The Glitch & The Fix, January 2015

Floor heating with pellet boiler

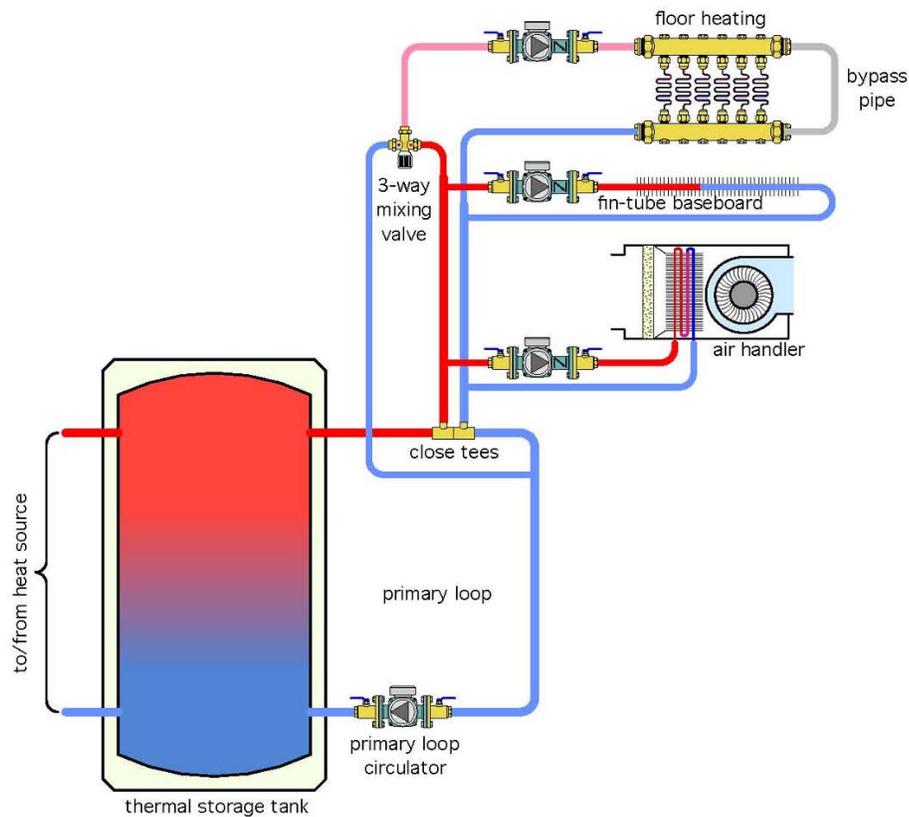
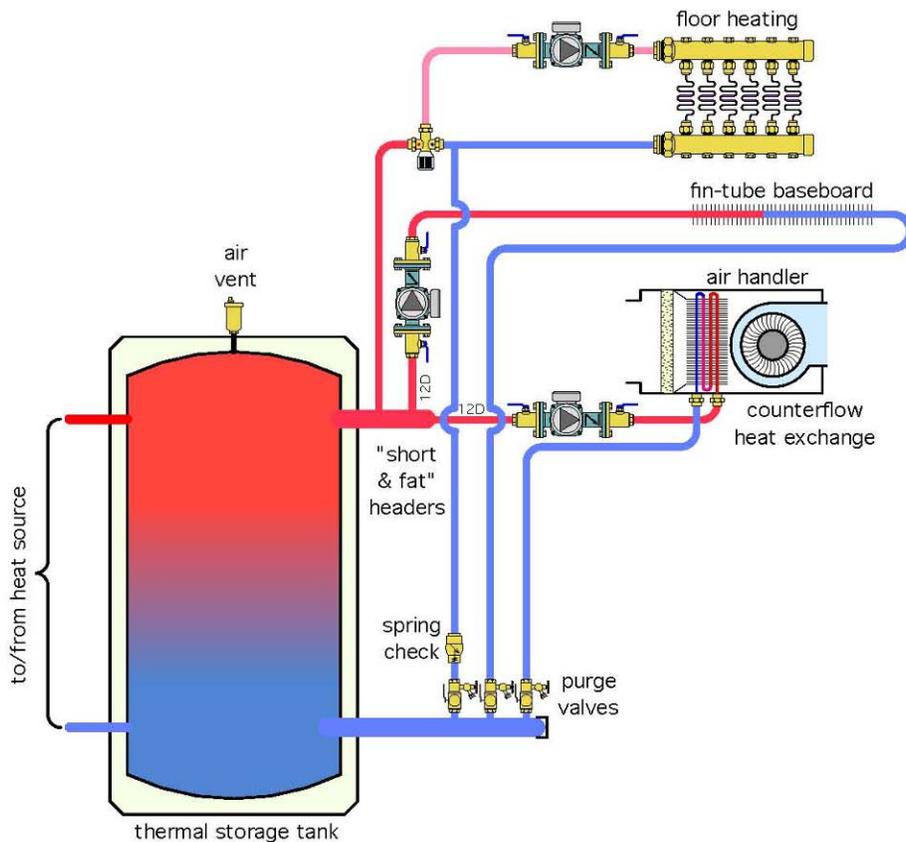
The drawing below is a close representation of a piping sketch that recently crossed my desk. The designer's intent was to supply a low-temperature floor-heating zone, as well as a higher-temperature baseboard zone and air handler, from a thermal storage tank heated by a pellet-fueled boiler.

Can you spot at least five details that should be changed or components that should be added?

There is no need to create a separate primary loop on the right side of the tank as shown in the Glitch drawing. Thus, the piping and circulator in the primary loop can be eliminated. The operating cost of the primary circulator, over the life of the system, also disappears.

1. A float-type air vent added to top of the thermal storage tank. Without this, it will be difficult (impossible) to remove air trapped about the piping connections.
2. Reversing the piping connections to the coil of the air handler. This creates counterflow heat exchange, which increases the rate of heat transfer from the coil, all other conditions being equal.
3. Adding purging valves to the return side of each load circuit.
4. Adding a spring-loaded check valve to the return side of the floor-heating circuit to prevent the possibility of reverse flow through the three-way mixing valve.
5. Removing the "bypass" piping, shown in gray, on the right side of the floor heating manifold. This piping was definitely there on the sketch I received. There is absolutely no purpose in having this piping.

If present, most of the flow entering the supply manifold would short-circuit through the bypass piping, rather than pass through the floor-heating circuits, the latter having much higher flow resistance than the bypass.

A properly piped buffer tank can provide excellent hydraulic separation between multiple load circuits. The key is to create “short and fat” headers that connect to the tank and create very little pressure drop. These headers and the tank itself then represent a common piping path with very low flow resistance. The result: good hydraulic separation between the load circulators.

Other details that have been corrected in the Fix drawing include:
